UNITED STATES PATENT AND TRADEMARK OFFICE

APPLICATION NO.	FILING DATE	FIRST NAMED INVENTOR	ATTORNEY DOCKET NO.	CONFIRMATION NO.
10/726,223	12/01/2003	Joseph H. Martin		3741
7590	10/28/2005		EXAMINER	
Donald W. Meeker Patent Agent 924 East Ocean Front #E Newport Beach, CA 92661			CADUGAN, ERICA E	
			ART UNIT	PAPER NUMBER
			3722

Office Action Summary	Application No.	Applicant(s)
	10/726,223	MARTIN, JOSEPH H.
	Examiner	Art Unit
	Erica E. Cadugan	3722

DETAILED ACTION

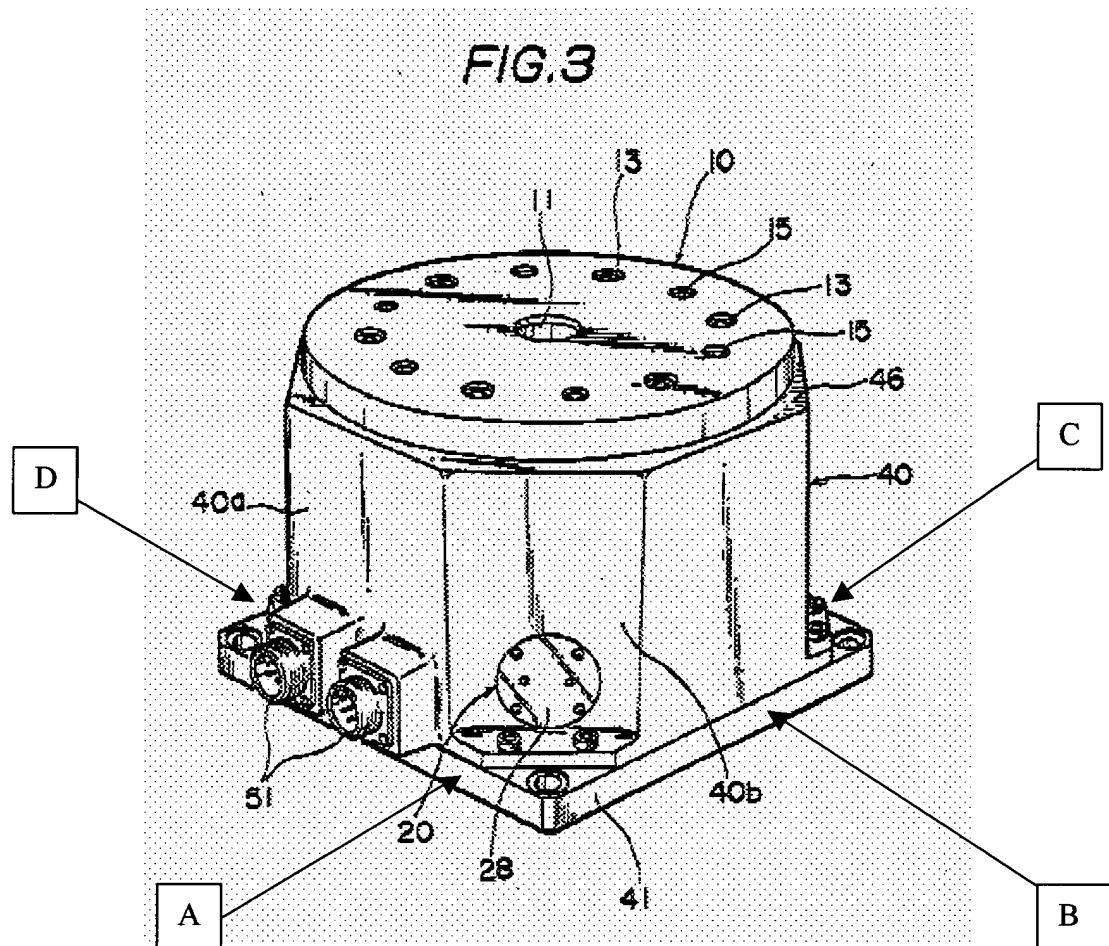
Specifically, as shown in the above labeled reproduction of Figure 3 from Teramachi, note that the indexer can be gripped by a vice to be held in a position where the table 10 extends in a generally horizontal plane (which position could be considered to be the “vertical position” of the block in the claim in that the block is thus positioned to rotate the table about a vertical axis, or which could be alternatively considered to be the “horizontal position” of the block in the claim in that the block holds the table in a position where it extends in a generally horizontal plane) by opposing vise jaws that contact sides B and D, or by opposing vise jaws that contact sides A and C. Additionally, particularly in light of the teachings of Teramachi that the indexer

“can be used in any position” and that the indexer can be used in “the vertical state in which the rotary table 10 rotates in a vertical plane” (col. 4, lines 50-58), it is noted that if the indexer was repositioned such that the table 10 rotates in a generally vertical plane, then it is noted that the indexer can be so arranged such that opposing vise jaws grip opposing sides A and C or grip opposing sides B and D in order to hold the device with the table 10 rotating in the vertical plane.

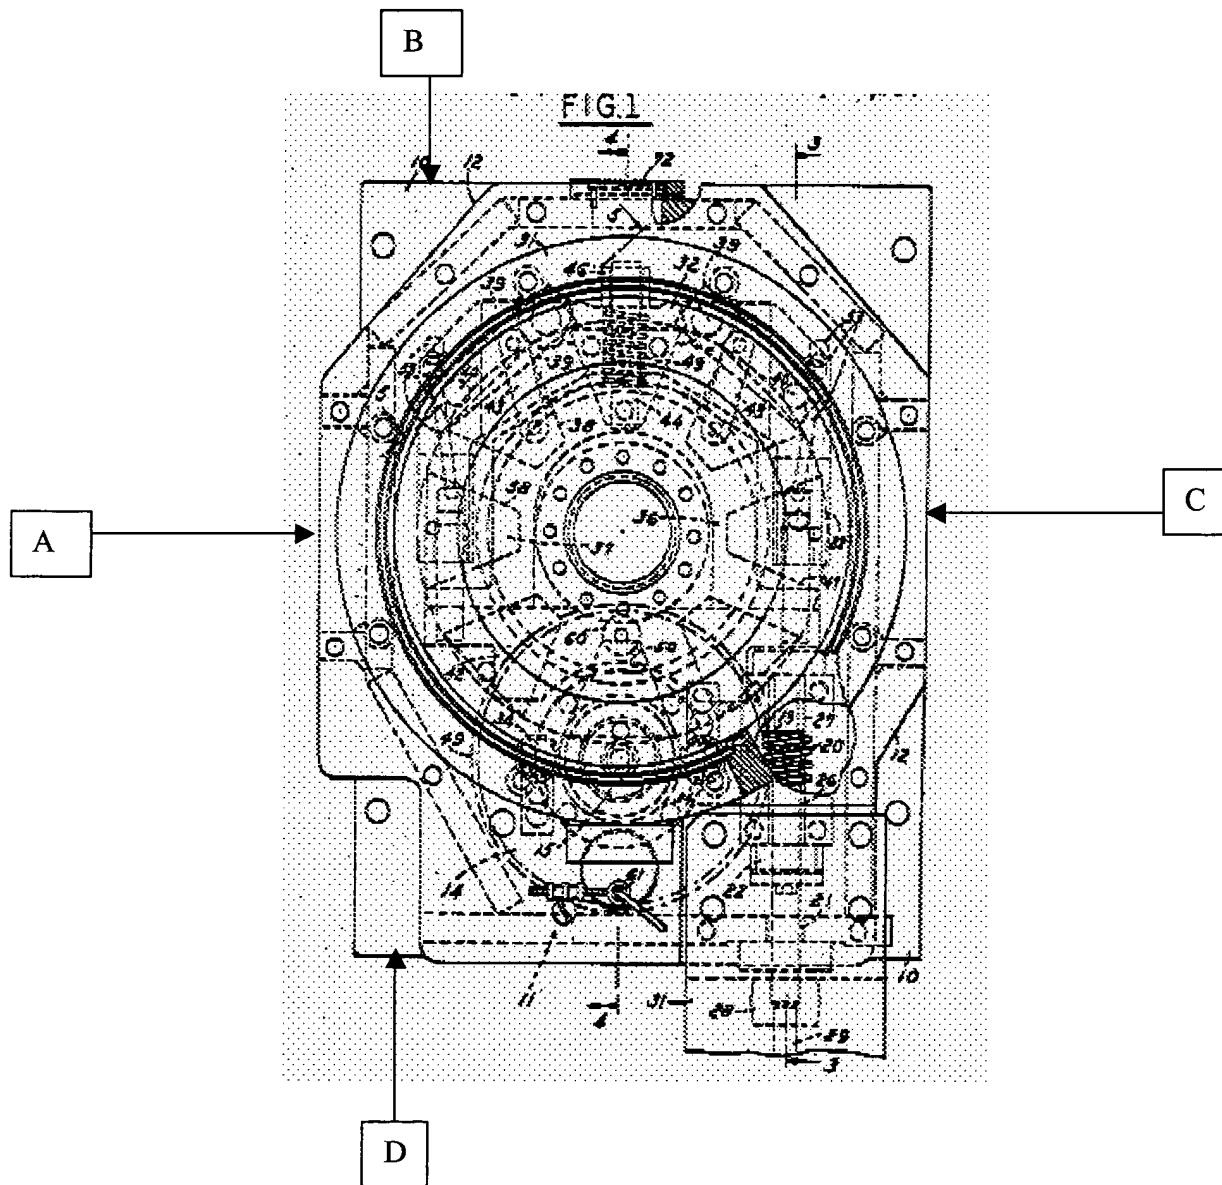
Specifically, as shown in the above labeled reproduction of Figure 1 from Bell, Sr., note that the indexer can be gripped by a vice to be held in a position where the table 32 extends in a generally horizontal plane (which position could be considered to be the “vertical position” of

the block in the claim in that the block is thus positioned to rotate the table about a vertical axis, or which could be alternatively considered to be the “horizontal position” of the block in the claim in that the block holds the table in a position where it extends in a generally horizontal plane) by opposing vise jaws that contact sides B and D, or by opposing vise jaws that contact sides A and C. Additionally, it is noted that if the indexer was repositioned such that the table 32 rotates in a generally vertical plane, then it is noted that the indexer can be arranged such that opposing vise jaws grip opposing sides A and C or grip opposing sides B and D in order to hold the device with the table 10 rotating in the vertical plane.

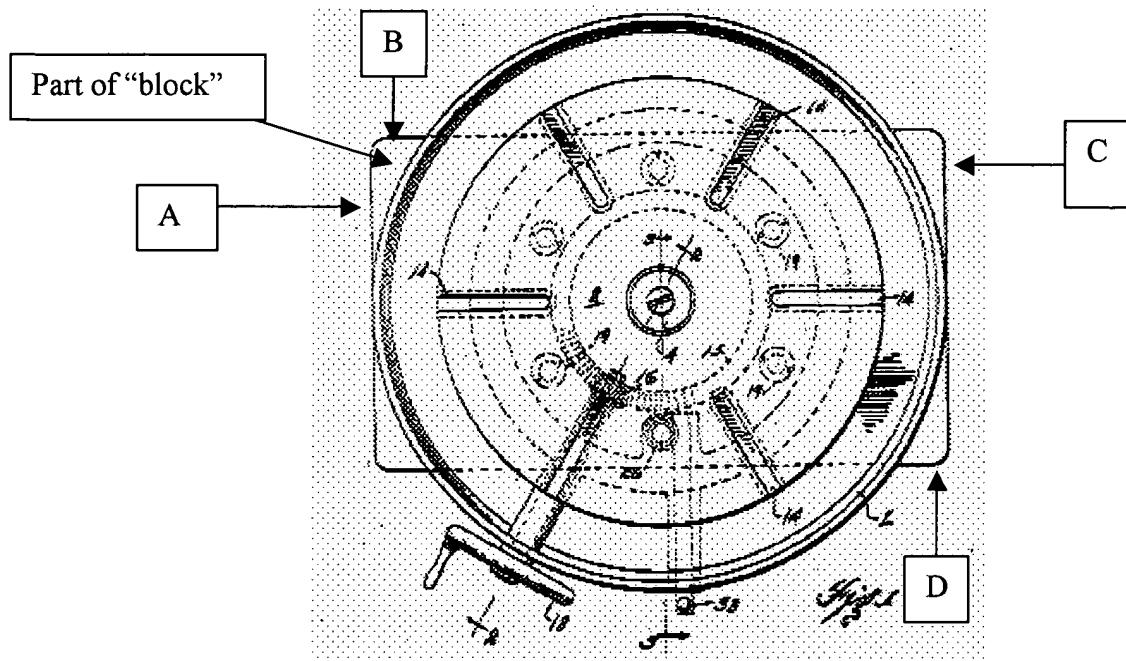
Buhr teaches an indexer device that includes a “block” including the rectangular element labeled in the reproduction of Figure 1 below and also including base member 1 (Figure 2).

Specifically, as shown in the above labeled reproduction of Figure 1 from Buhr, note that the indexer can be gripped by a vice to be held in a position where the table 2 extends in a generally horizontal plane (which position could be considered to be the “vertical position” of the block in the claim in that the block is thus positioned to rotate the table about a vertical axis, or which could be alternatively considered to be the “horizontal position” of the block in the claim in that the block holds the table in a position where it extends in a generally horizontal plane) by opposing vise jaws that contact sides B and D, or by opposing vise jaws that contact sides A and C. Additionally, it is noted that if the indexer was repositioned such that the table 2 rotates in a generally vertical plane, then it is noted that the indexer can be arranged such that opposing vise jaws grip opposing sides A and C or grip opposing sides B and D in order to hold the device with the table 2 rotating in the vertical plane.

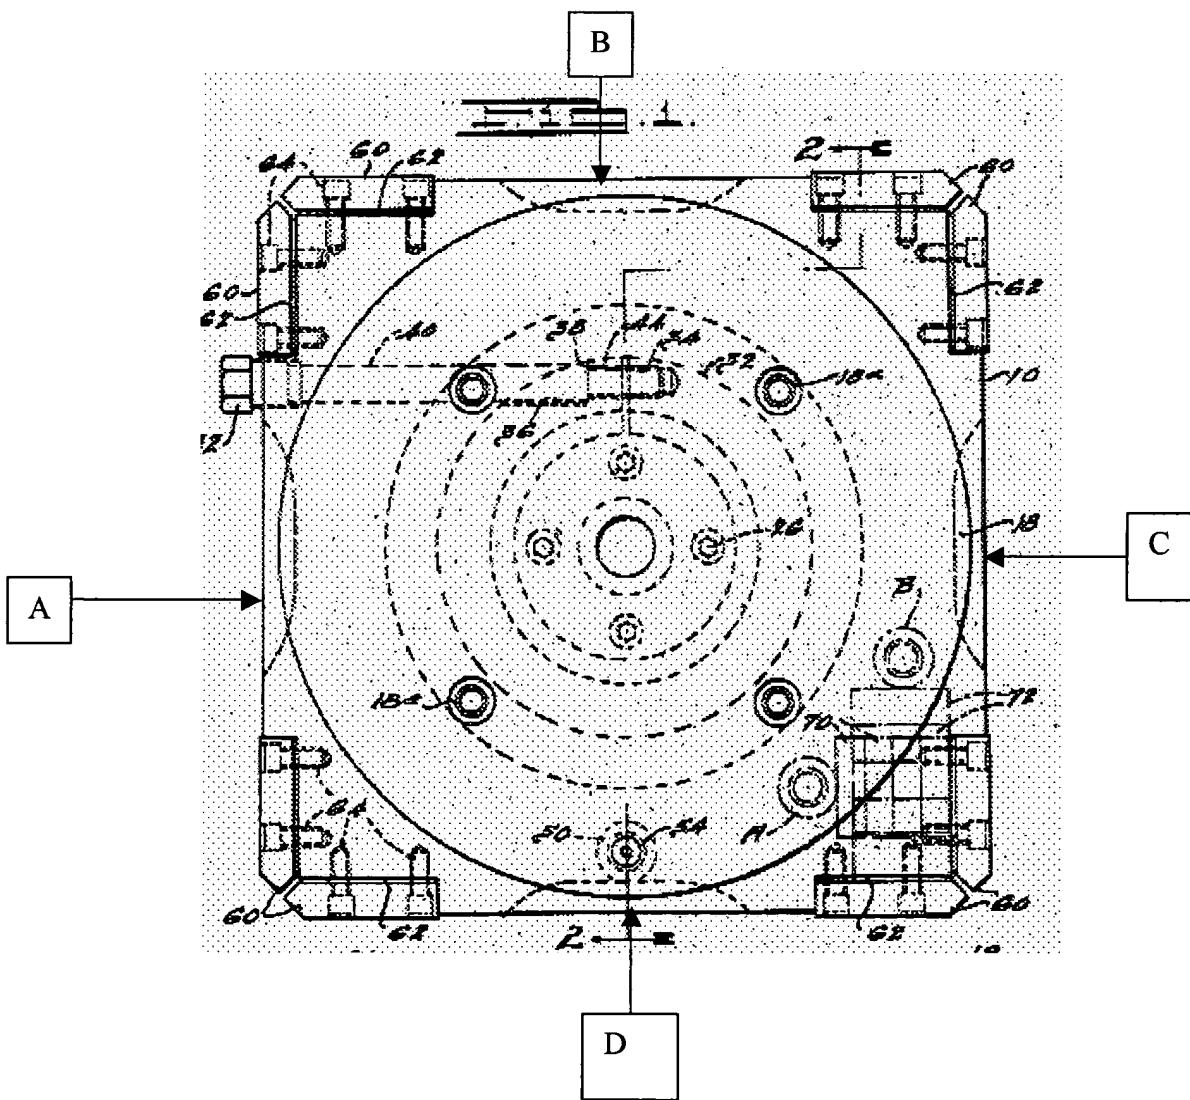
Specifically, as shown in the above labeled reproduction of Figure 1 from Saunders, note that the indexer can be gripped by a vice to be held in a position where the table 18 extends in a generally horizontal plane (which position could be considered to be the “vertical position” of the block in the claim in that the block is thus positioned to rotate the table about a vertical axis, or which could be alternatively considered to be the “horizontal position” of the block in the claim in that the block holds the table in a position where it extends in a generally horizontal plane) by opposing vise jaws that contact sides B and D, or by opposing vise jaws that contact sides A and C. Additionally, it is noted that if the indexer was repositioned such that the table 2 rotates in a generally vertical plane, then it is noted that the indexer can be arranged such that opposing vise jaws grip opposing sides A and C or grip opposing sides B and D in order to hold the device with the table 18 rotating in the vertical plane.

Re claim 9, note that grooves 44, one of which is shown in Figure 2, are located in each of the aforescribed four sides A-D (Figure 1), and are used “for reception of suitable or conventional clamping means (not shown) employed for clamping the base 10 to the table of the supporting surface of a machine tool or the like” (col. 3, lines 18-22). Thus, at least as broadly claimed, these grooves 44 serve to “align” the block 10 as they are engaged by the clamping means.
